**ALBERTA TRANSPORTATION
SPRINGBANK OFF-STREAM RESERVOIR
PROJECT
Response to NRCB and AEP
Supplemental Information Request 2,
dated November 18, 2019**

Prepared for:
Alberta Transportation

Prepared by:
Stantec Consulting Ltd.

April 2020

Figure 9-5. POI Hydrographs near Northeastern Edge of Reservoir

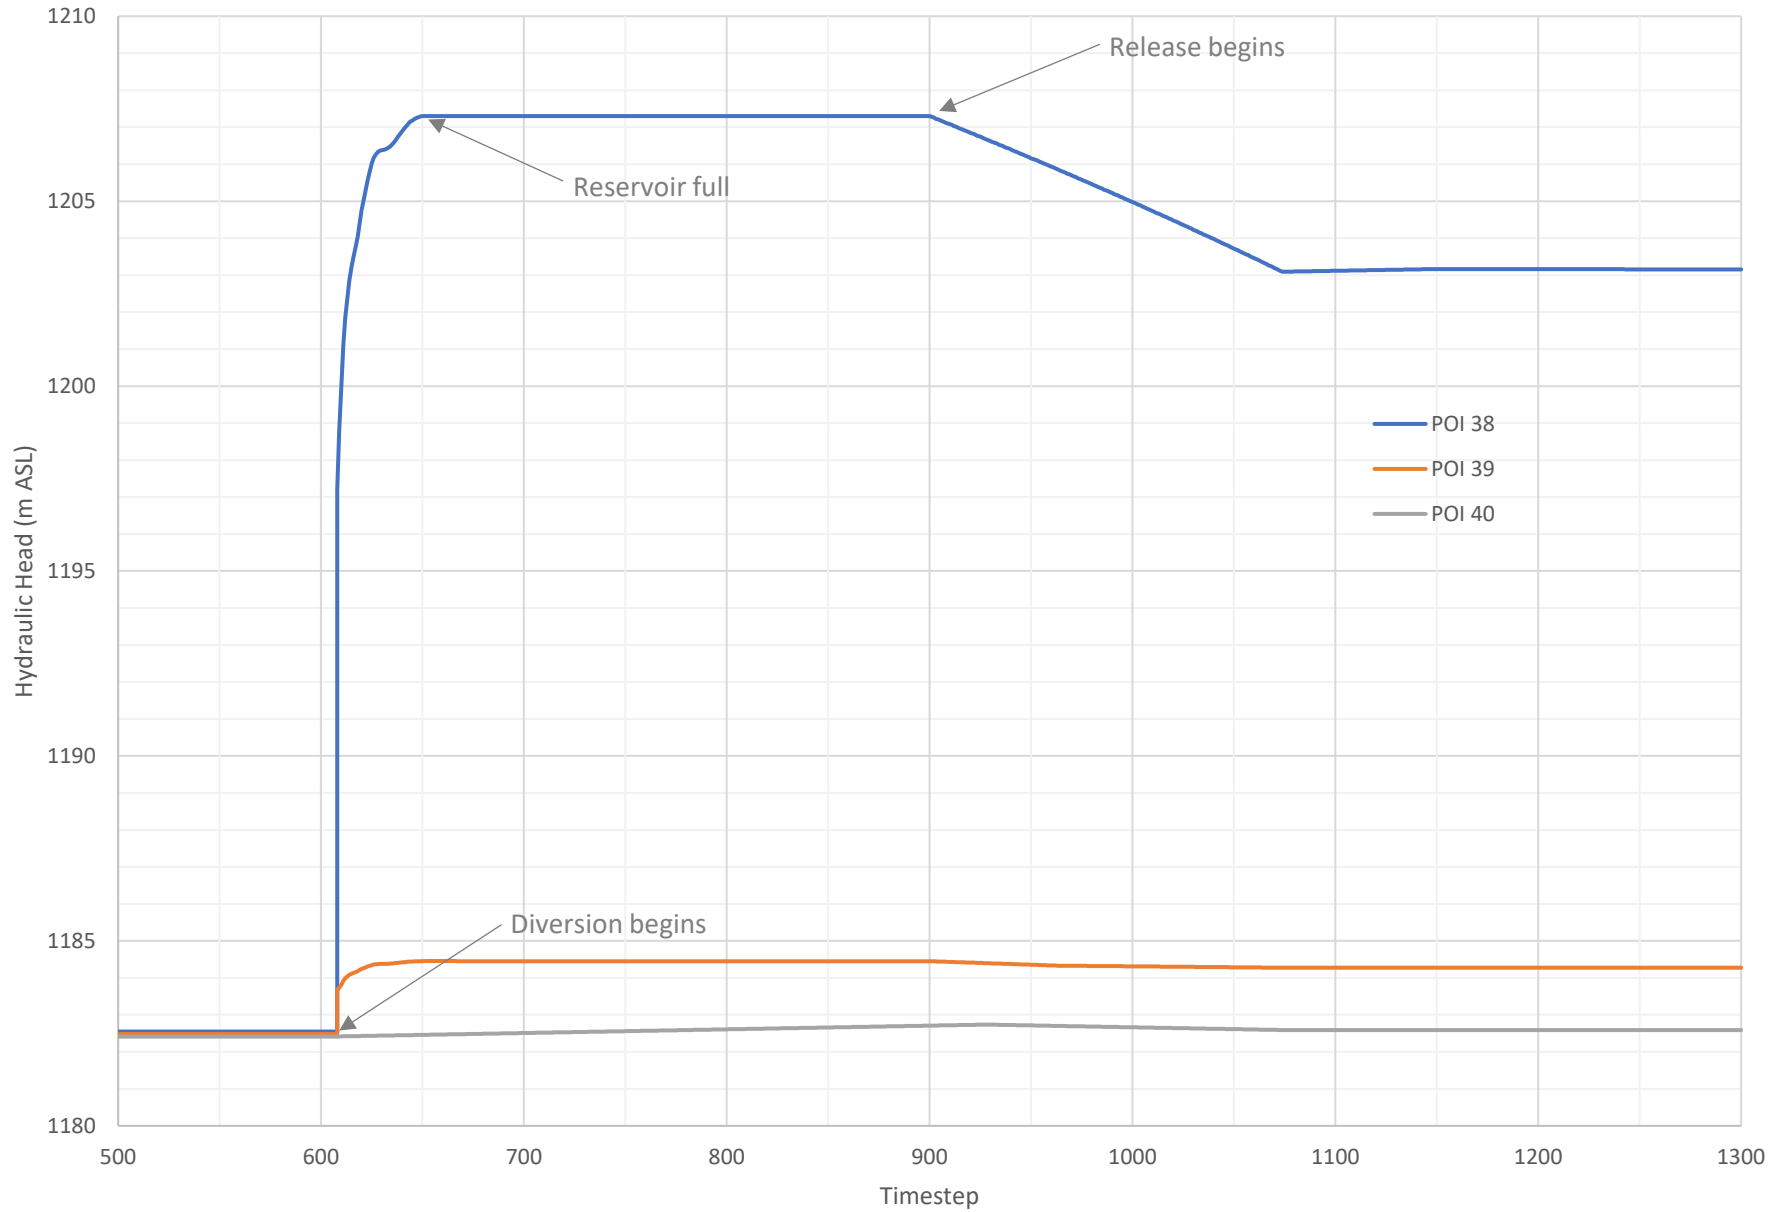
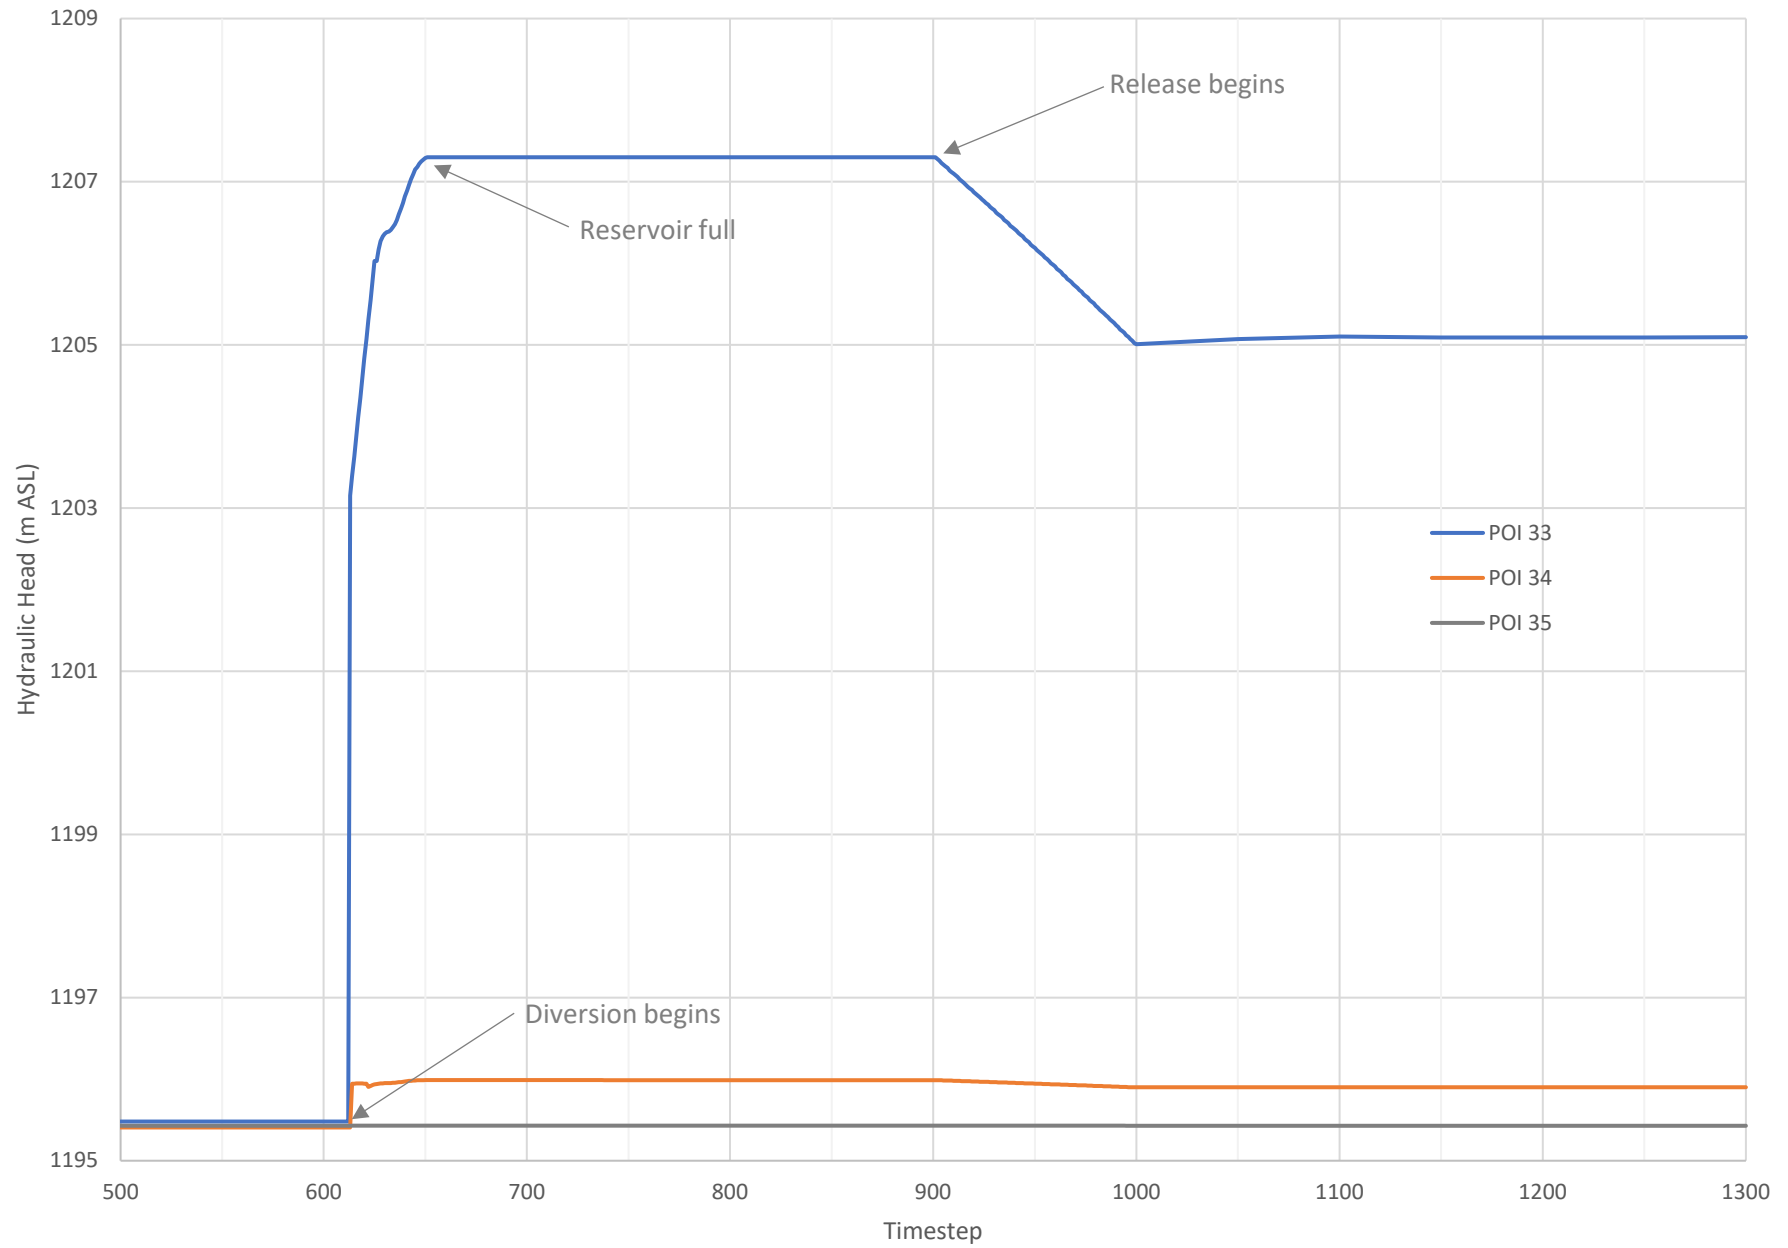
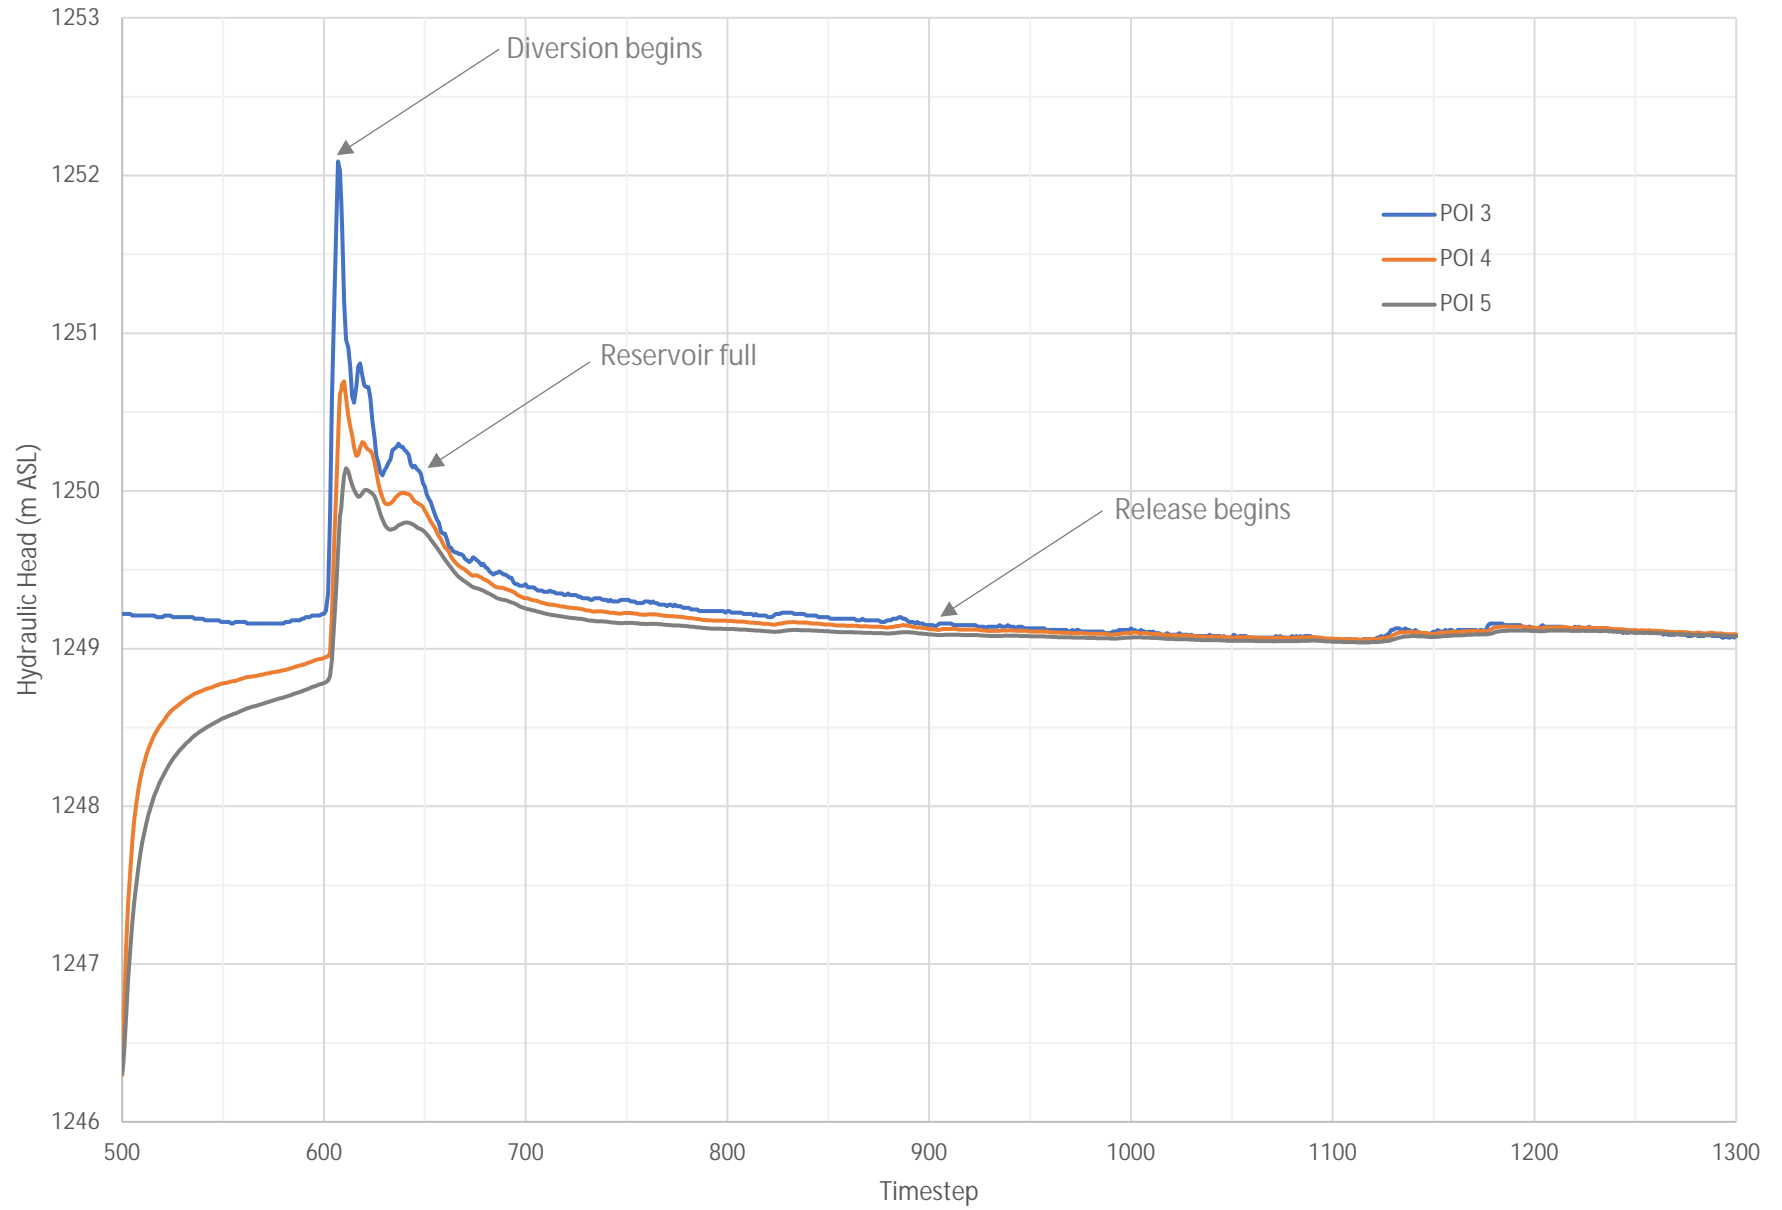
No time series plots are provided for the Points of Interest in Appendix IR42-1, Figure 5-4.

a. Provide the plots requested in Question 258.

a. Figure 9-1 presents the locations of the points of interest (POI). The following discussion presents time series hydrographs for POI in areas near the diversion channel and reservoir. All timesteps referenced in Figure 9-2 to Figure 9-6 are one-hour increments of elapsed time since the start of the simulation for the design flood.

Figure 9-2 presents hydrographs for three POI (24, 25 and 26) near the north side of the diversion channel. Point 26 shows the response to water levels in the channel resulting from the diversion of water from Elbow River. Point 25 is located approximately 10 m north of Point 26 and shows a delayed and dampened response, increasing approximately 4 cm beginning at timestep 605, followed by a gradual increase of 6 cm by timestep 1,300 (the end of the simulation). Point 24, located approximately 20 m from the channel, shows further dampening with effectively no response immediately after the diversion begins, followed by a lagged 8 cm increase by timestep 1,300.

Figure 9-3 presents hydrographs for POI on the south side of the diversion channel. The results are similar to observations for the north side of the diversion channel, although a more immediate and higher magnitude response is observed at the nearest point (Point 27) to the channel. Point 27 on the south edge of the channel shows the water level response due to the diversion of water within the channel. Point 28 is located approximately 10 m from the channel and shows a dampened response, increasing a maximum of 60 cm between timestep 605 and 616, but decreasing over the remainder of the simulation. At Point 29, located approximately 20 m from the channel, no response to the diversion of water is observed.

Figure 9-4 presents hydrographs for POI on the southeastern edge of the off-stream reservoir. Point 38 shows the response to the reservoir water reaching a maximum level of 1,207.3 m asl during the design flood, and following release of the water, remaining near the ground surface after the design flood has passed (to simulate continued near surface saturation). At Point 39, located approximately 10 m from the reservoir, an increase in hydraulic head of 2.1 m is followed by a gradual decrease (once water is released after the design flood) over the remainder of the simulation. Further dampening of effects on water levels is observed away from the reservoir, with only approximately 0.30 m of change at Point 40, located

Figure 9-5 presents hydrographs for POI on the northeastern edge of the reservoir. Point 33 shows the response to retention of water when the reservoir water reaches a maximum level of 1,207.3 m asl (during the design flood) and remaining near the ground surface after the design flood has passed. At Point 34, located approximately 35 m from the reservoir, a maximum increase in hydraulic head of 0.56 m is followed by decreasing levels after the design flood has passed for the remainder of the simulation. Further dampening is observed away from the reservoir, with essentially no change in water levels noted during the design flood at Point 35, located approximately 90 m from the reservoir.

Figure 9-6 presents hydrographs for POI near Elbow River south of the LAA. Hydraulic head changes are observed in the alluvium as a result of changes in river stage during the design flood. Point 3, adjacent to the river, shows the response to the specified head over the transient flooding simulation. Point 4 and Point 5 show an initial increase between timestep 500 to 600 when the simulation is adjusting from the steady state hydraulic head values to the transient head values specified for the river. Following the initial increase, the dampening effect is observed in the sand and gravel aquifer at distances of 30 m and 60 m from the river, respectively.

Soil Map Units in the Project Development Area and Local Assessment Area with a focus on ZREC in the Northwest

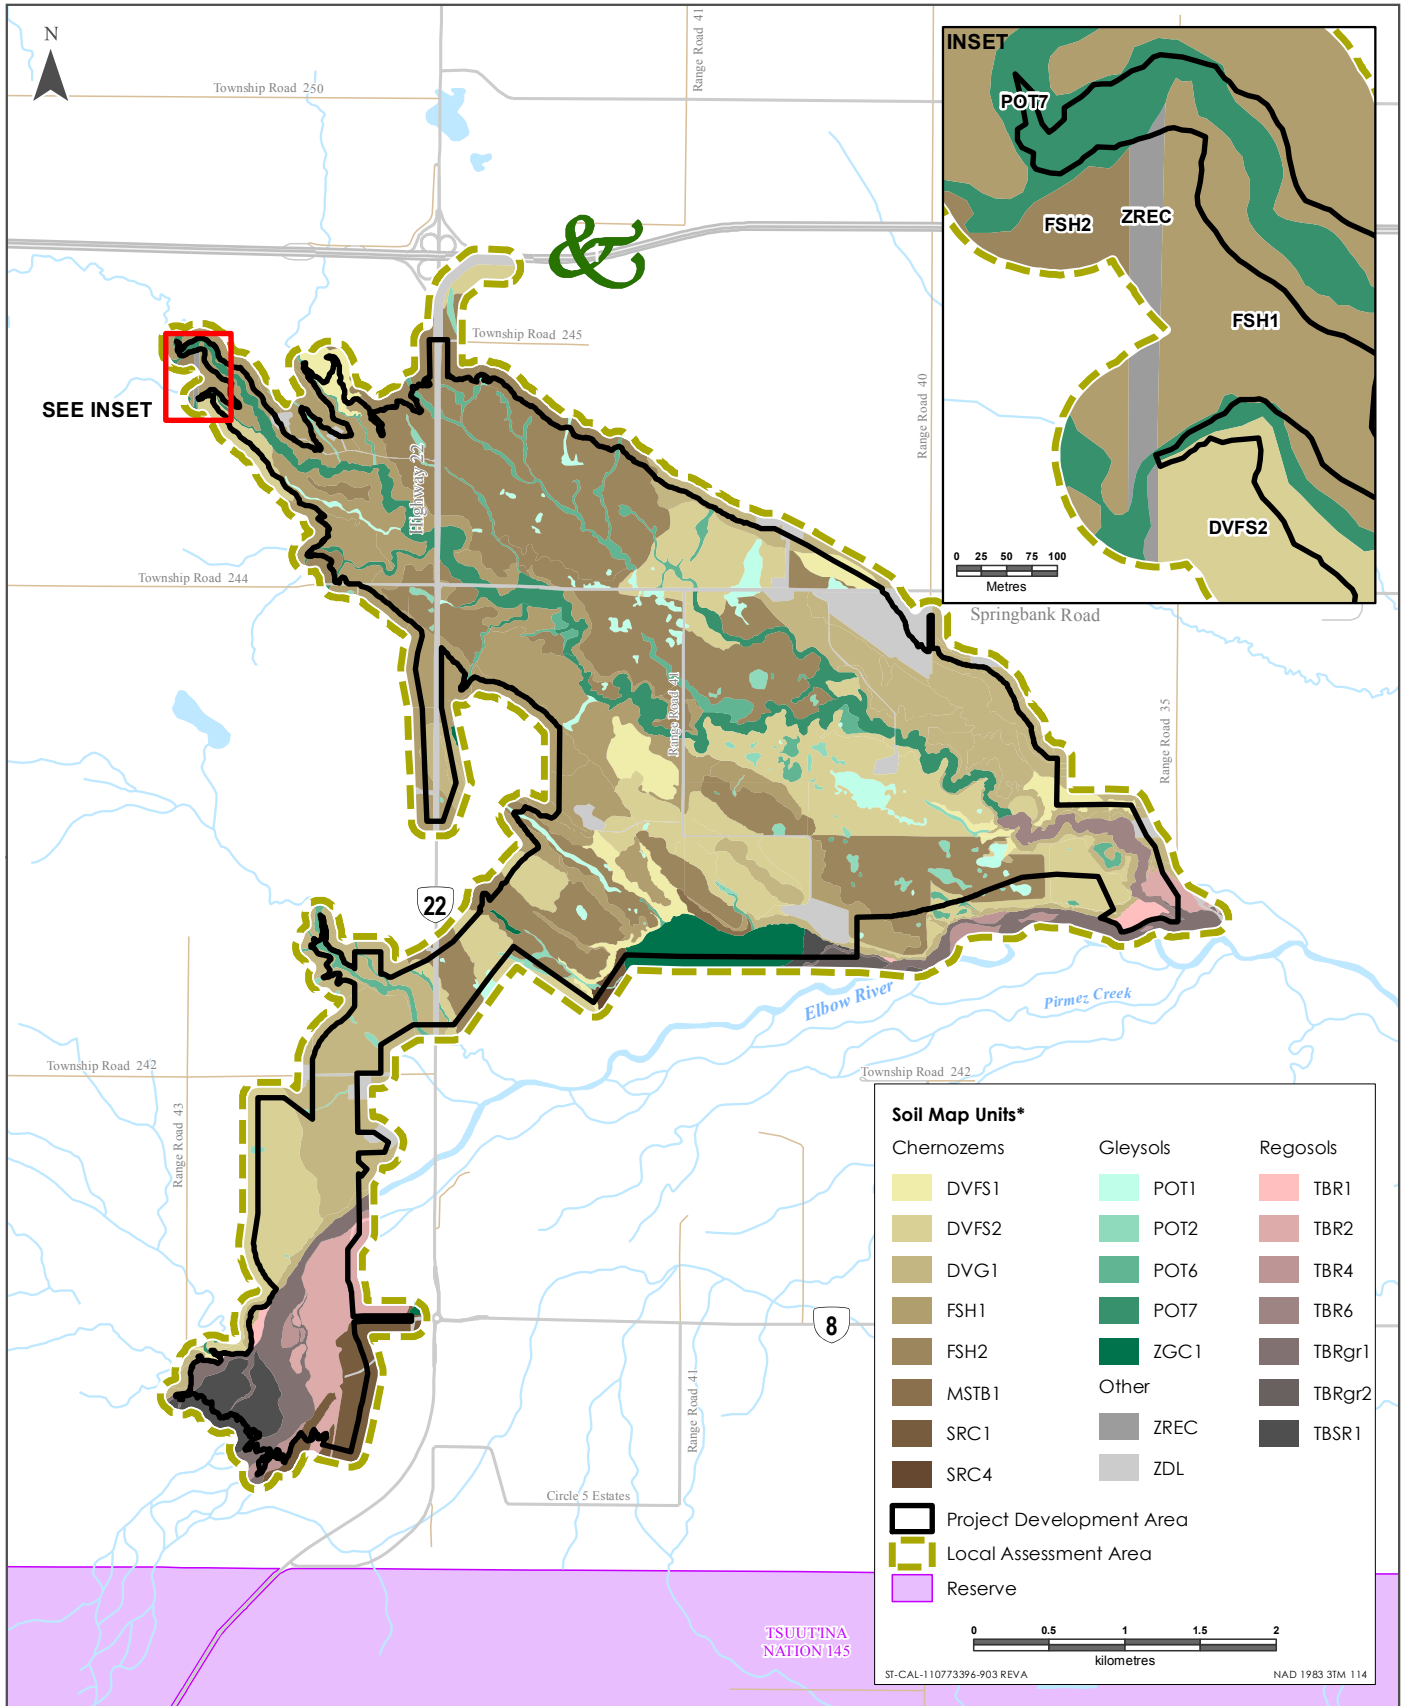
- a. Respond to the original SIR1 question 385a and provide a map at a 1:5000 scale or finer resolution for the ZREC unit. The decision not to undertake higher resolution mapping due to the small size of the ZREC unit is not reasonable. Detailed mapping is required because Figure 9-5 (Volume 3A, page 9.25) does not clearly depict the location of the ZREC unit.**

- a. A map (Figure 83-1) is provided at a scale of 1:5,000 to show the location of the ZREC map unit delineation.
